**TRANSMITTAL OF THE ADDENDUM TO THE WORK PLAN FOR THE BURIAL
GROUNDS OPERABLE UNIT REMEDIAL INVESTIGATION/FEASIBILITY STUDY
AT THE PADUCAH GASEOUS DIFFUSION PLANT, PADUCAH, KENTUCKY, SOLID
WASTE MANAGEMENT UNIT 4 SAMPLING AND ANALYSIS PLAN
(DOE/OR/07-2179&D2/A2/R2) [REPLACEMENT PAGES FOR THE D2/A2/R1
DOCUMENT]**

Document Identification: ***Addendum to the Work Plan for the Burial Grounds Operable Unit Remedial Investigation/Feasibility Study At The Paducah Gaseous Diffusion Plant, Paducah, Kentucky, Solid Waste Management Unit 4 Sampling and Analysis Plan DOE/OR/07-2179&D2/A2/R2***

Date Issued—June 2012

Figure 12. Surface Soil Sampling Grid

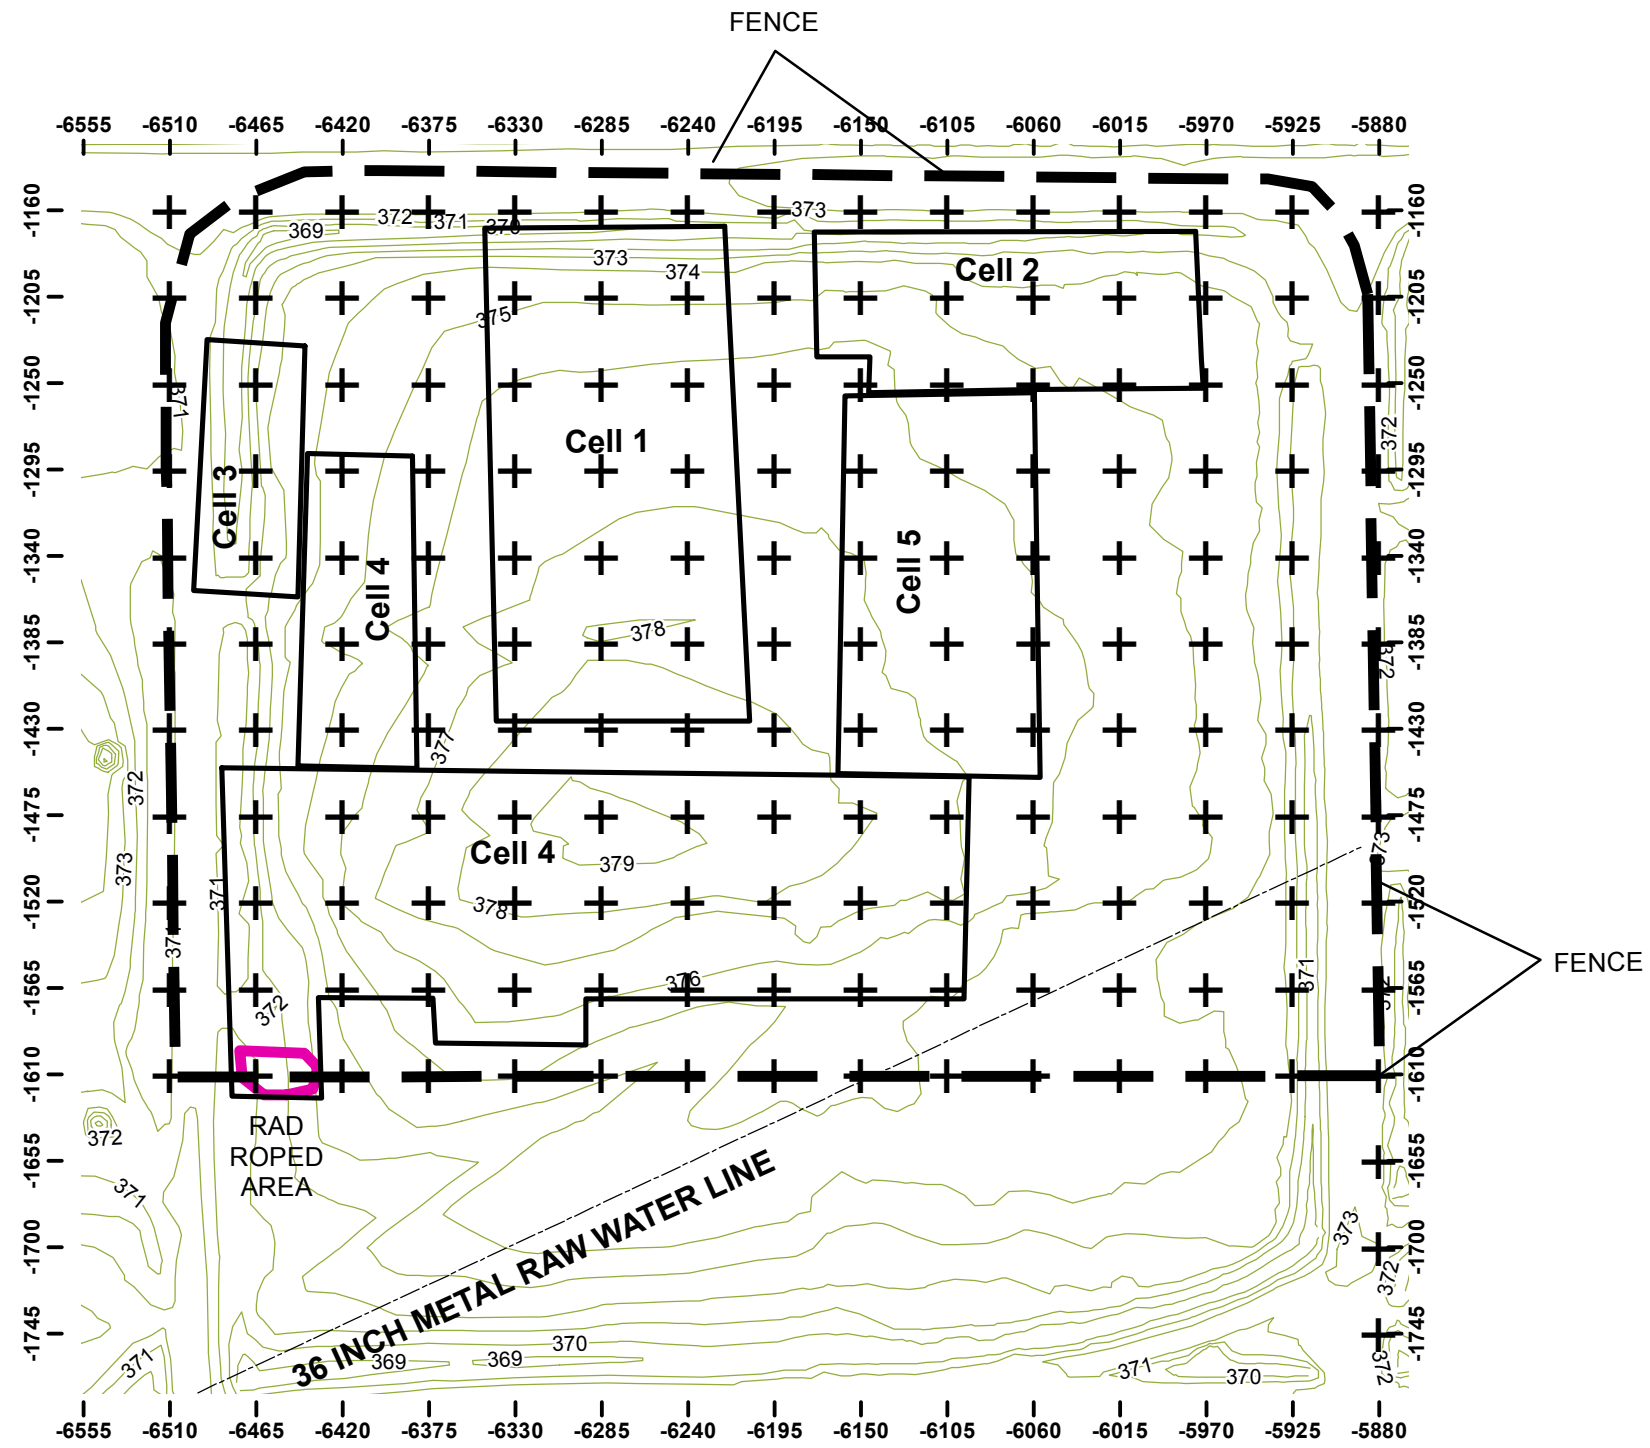
- 1) Corrected spelling error and
- 2) The grid for the surface soil sampling was incorrectly applied across an area beyond the Solid Waste Management Unit 4 boundary. As a result of this correction, a new grid has been provided (Figure 12) and the sample count changed from 180 samples

to 154 samples for field lab samples and from 18 samples to 16 samples for fixed-base lab samples.

Surface soil samples will be collected at depths between 0 and 1 ft bgs with the use of a stainless-steel sampler, hand auger, spoon, trowel, spade, or scoop. Samples will be collected as five-point composites from 45-ft grids, as shown on Figure 12, resulting in 154 composite samples. Collection of the five points for each composite is shown in Figure 13. Unless otherwise noted, one grab sample will be collected from the center of the grid. Four additional grab samples will be collected 15 ft from the center point in each cardinal direction (north, south, east, and west). On alternating grids, grab samples will be collected from the center of the grid, and four additional grab samples will be collected 15 ft from the center point in each secondary direction (northeast, northwest, southeast, southwest).
